1. **Title:** Burger King Restaurant Remodel
Address: 227 Mount Hermon Road
Applicant: Sunny Ghai / Ishar Investments
Property Owner: Scotts Valley Plaza, L.P.
Project Description: Consideration of a Design Review application DR20-002 and a Sign Design Review DR20-003 for an exterior remodel of an existing 2,340 square foot restaurant building (Burger King) including new parapet walls, new finishes and new signage.
Staff: Brenda Stevens, Associate Planner, bstevens@scottsvally.org

**City of Scotts Valley
PLANNING COMMISSION
STAFF REPORT**

Applications: Design Review #DR20-002, and Sign Design Review #DR20-003

Project Description: Consideration of a Design Review application to remodel an existing 2,340 square foot restaurant building (Burger King) and a Sign Design Review to replace the existing building signage.

A-3

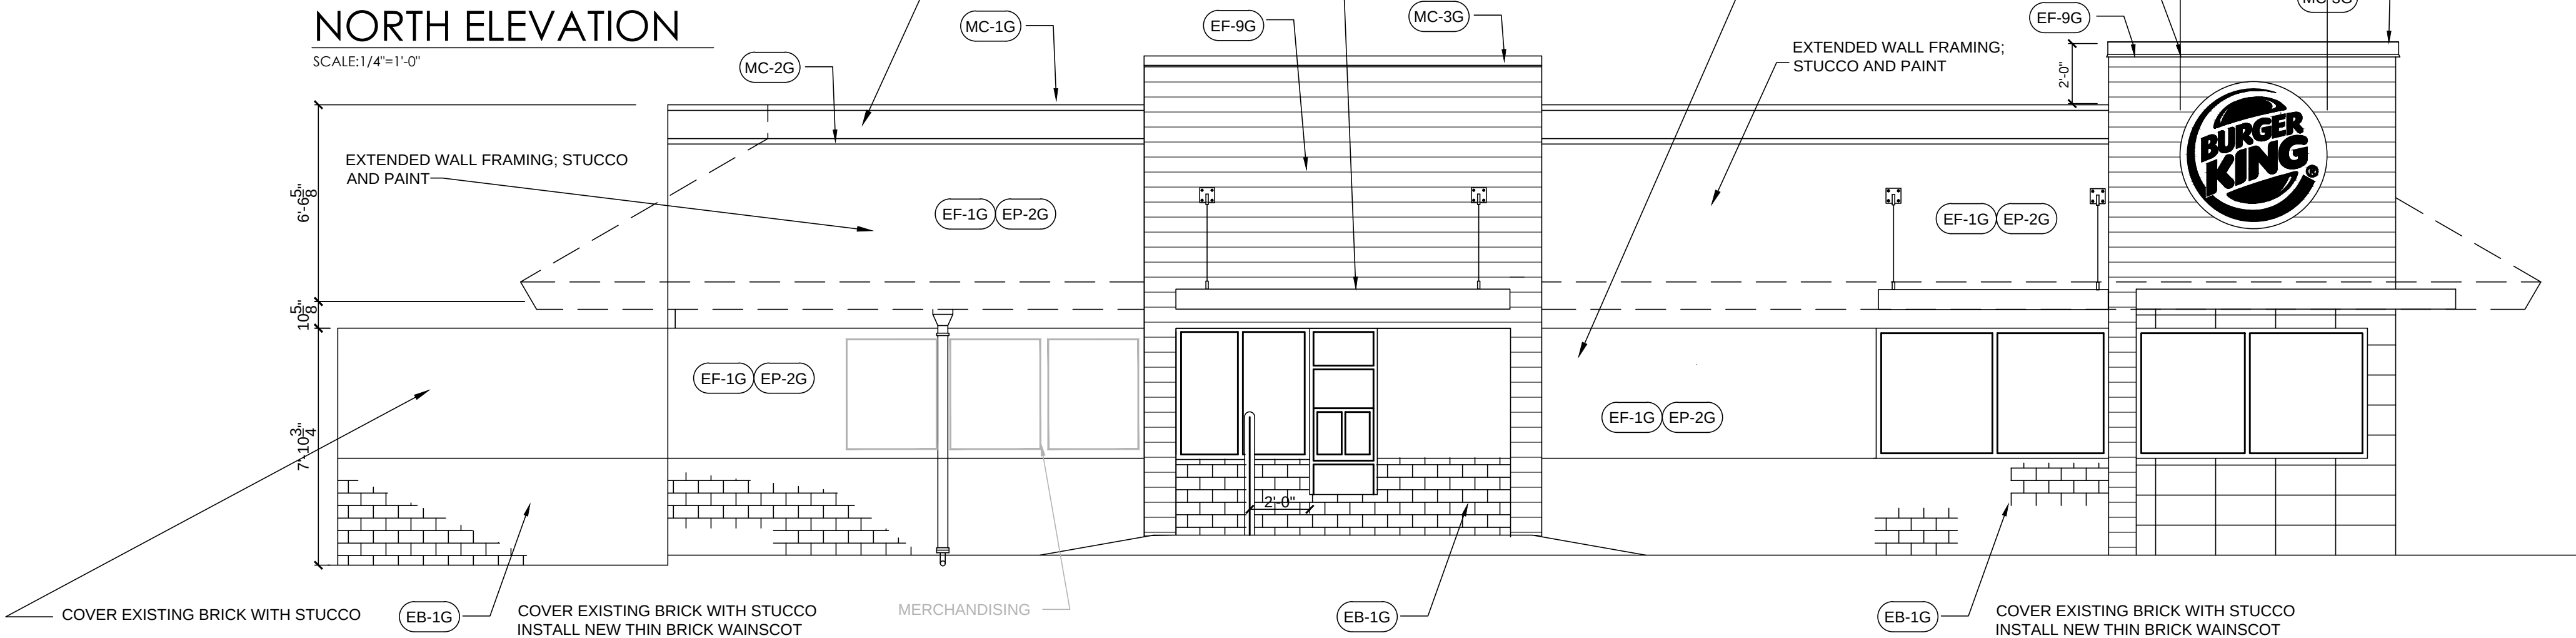
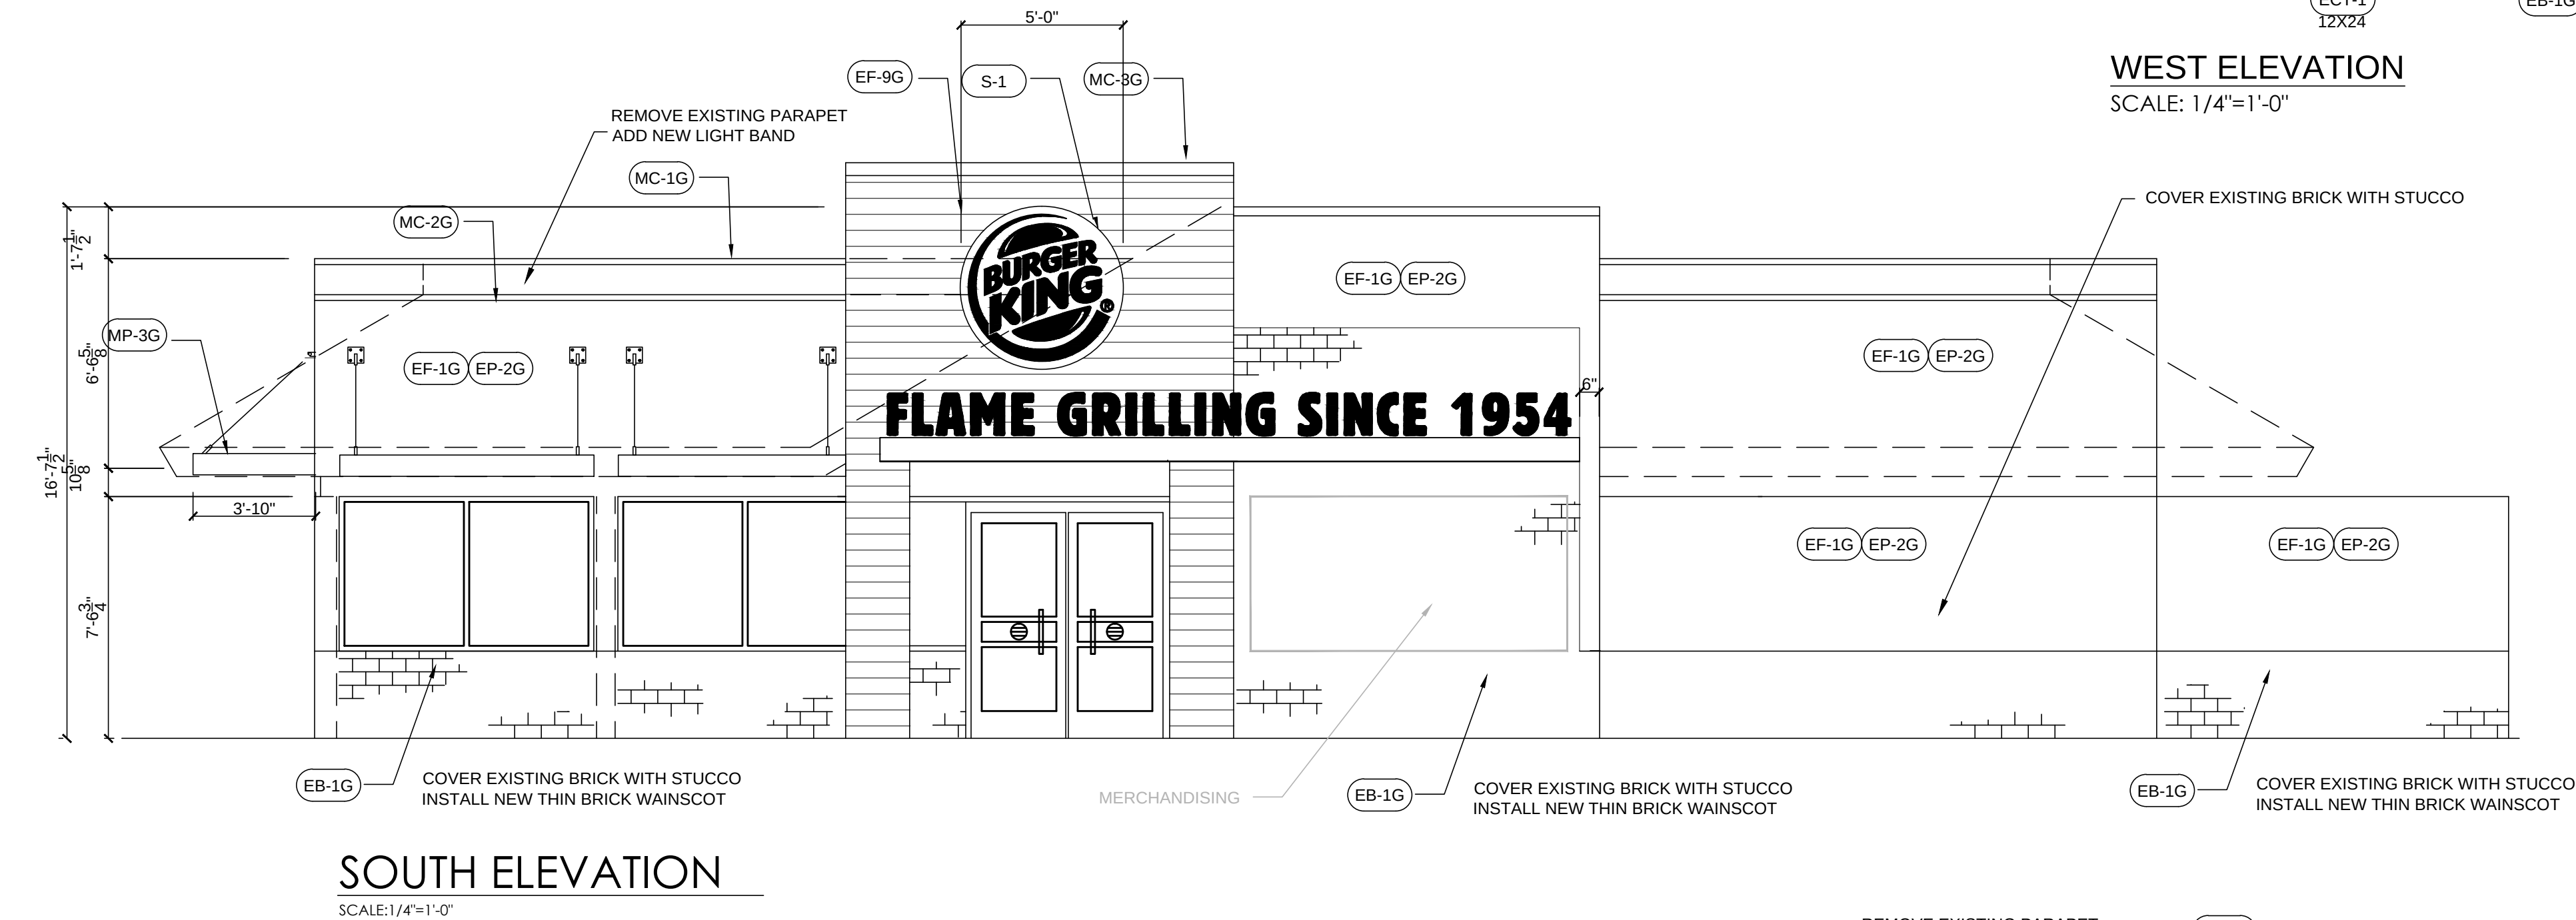
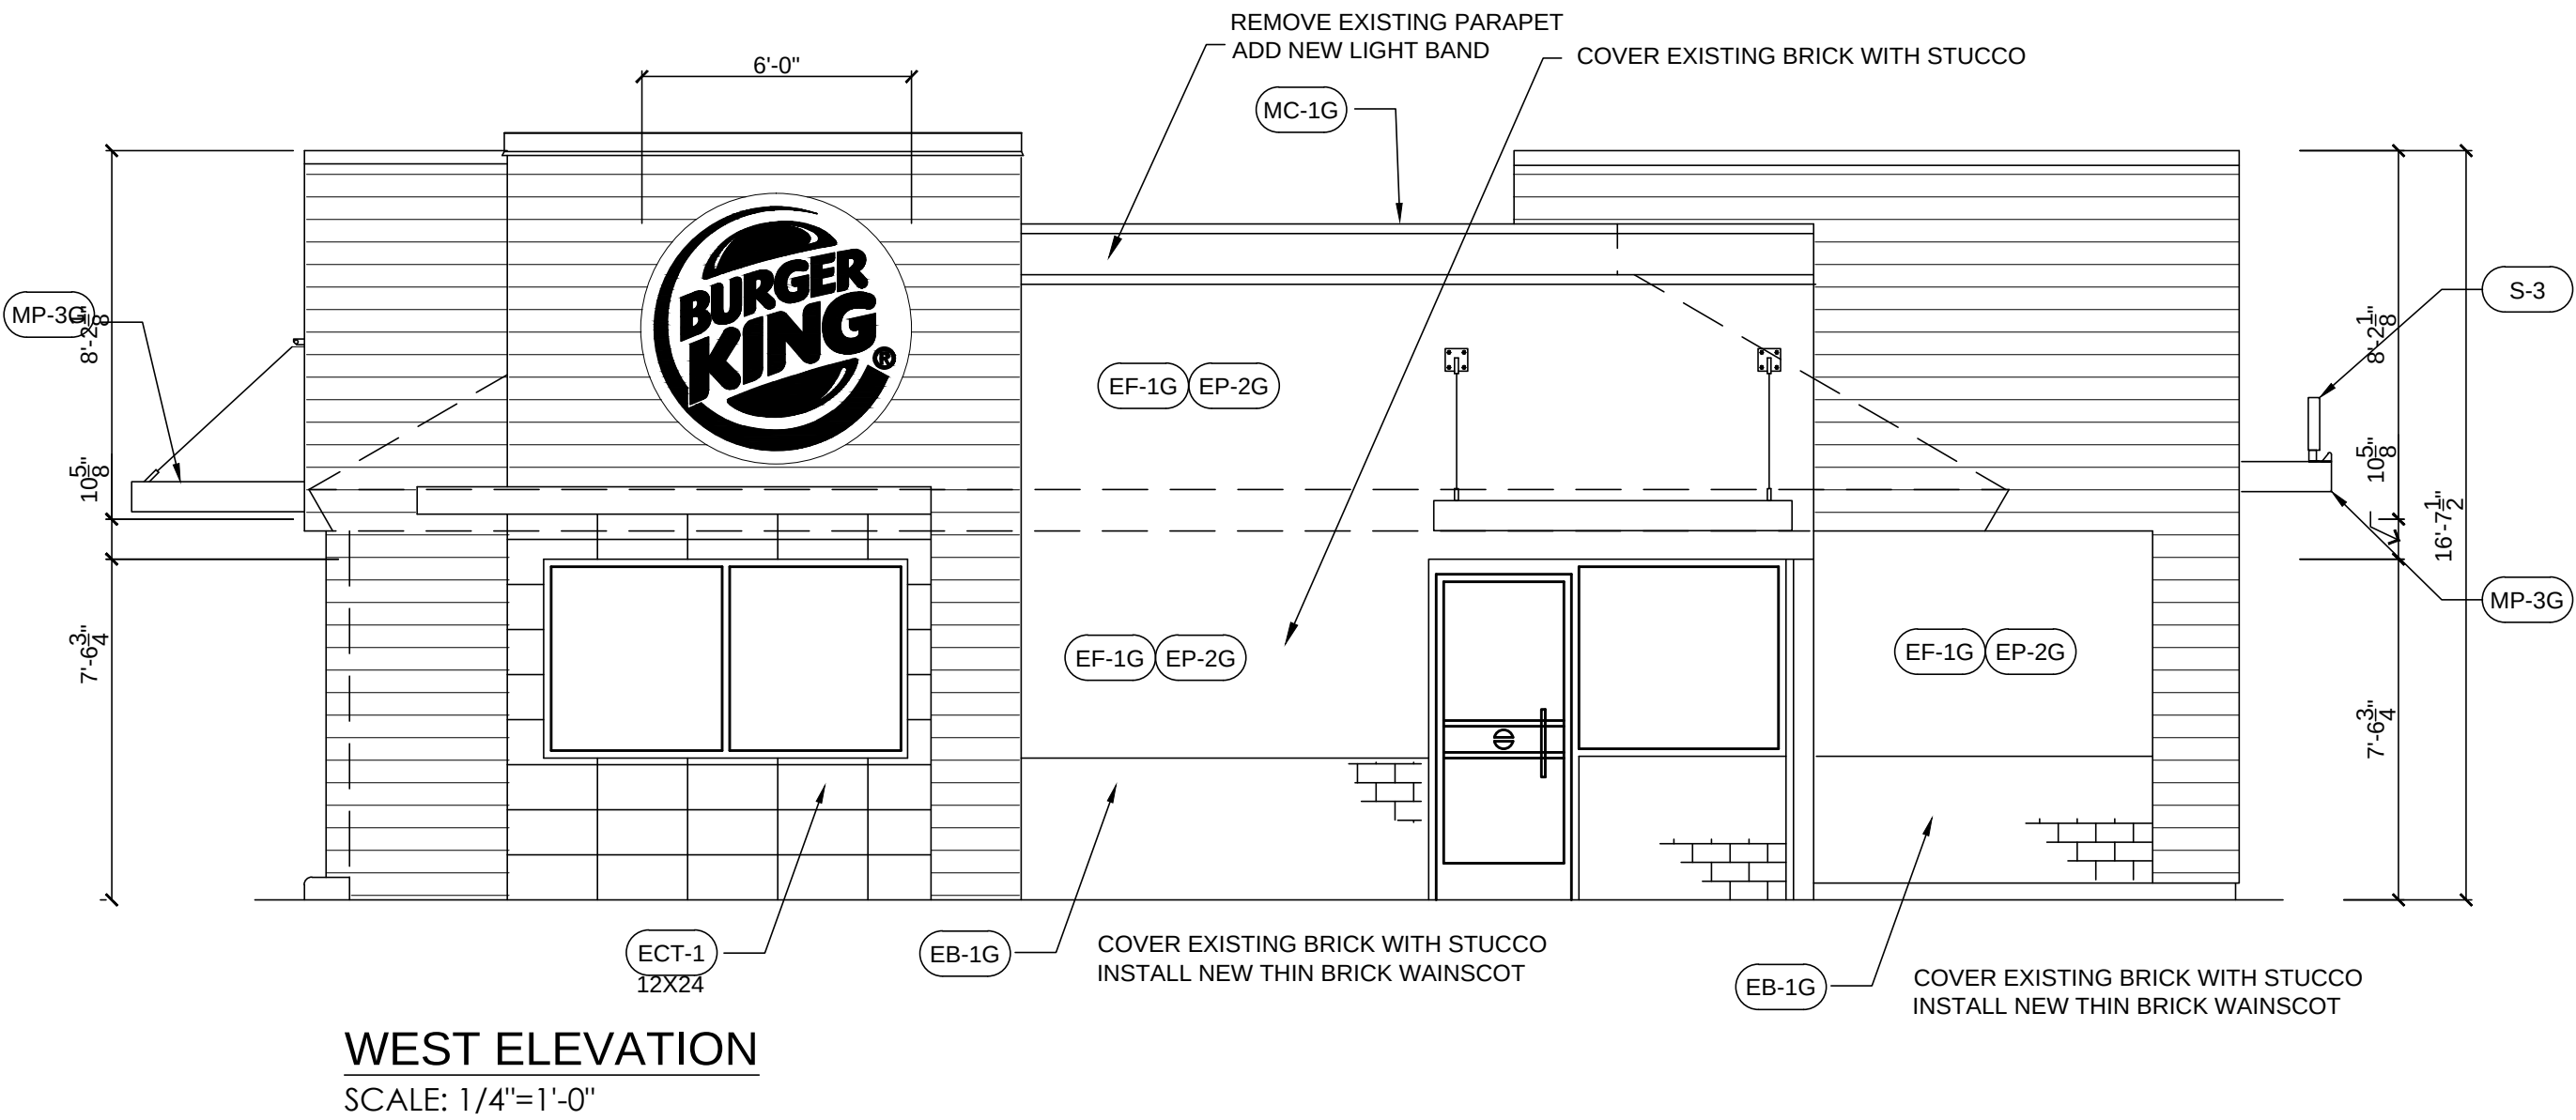
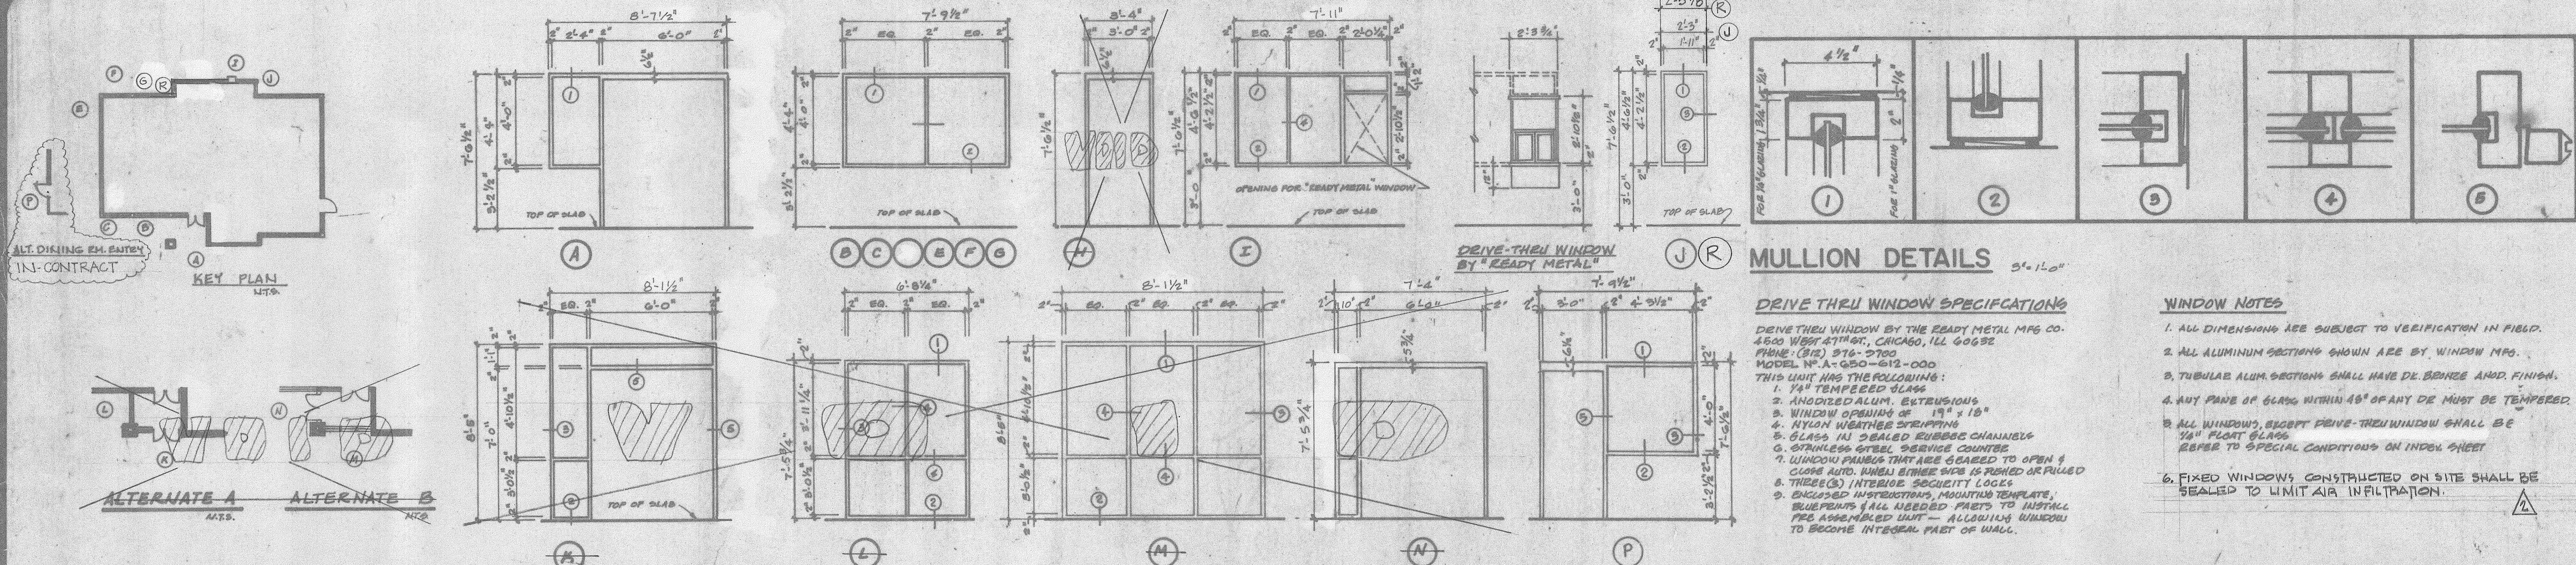
Staff believes two sections of the roof-top light band should be eliminated. The first section is (Sheet A-3 listed as North Elevation) along the drive-thru elevation to the left of the drive-thru window between the menu board and the pick-up window. The second section is (Sheet A-3 listed as East Elevation) the rear side of the building, from corner to corner. By eliminating these portions of the light band, staff believes it will lessen the visual light impact on the adjacent residence of the Spring Lakes Mobile Home Park and will not impact the building visibility or identification in any significant way.

- Number of pad signs will be subject to review and approval by the CDD:
Staff recommends reducing the quantity of logo signs from three to two and has stated this in the Conditions of Approval. By eliminating the logo sign on Sheet A-3 called out as the North Elevation near the building corner of the drive-thru exit, staff believes that this will reduce unnecessary light impact for residential neighbors of adjacent Spring Lakes Mobile Home Park. As this logo sign will be the least visible for business identification purposes for traffic along Mount Hermon Road staff believes the elimination of this sign will not significantly impact the business.

6. The applicant shall eliminate two sections of the roof-top light band on the drive-thru elevation located to the left of the drive-thru window (when facing the window) between the menu board and the pick-up window (Sheet A-3 listed as North Elevation). The second section is (Sheet A-3 listed as East Elevation) at the rear side of the building, from corner to corner.

7. The applicant shall eliminate one of the three logo signs for a total of two logo signs. The logo sign on Sheet A-3 listed on the plans as the North elevation on the drive-thru elevation shall be eliminated.
8. The two remaining logo signs (Sheet A-3 one listed on West and listed as South elevation) shall be reduced in size by one foot in diameter. The 6 foot in diameter logo sign shall be reduced to 5 feet and that the 5 foot diameter logo sign be reduced to 4 feet.
9. The applicant shall submit revised plans showing the light band and signage changes as conditioned.
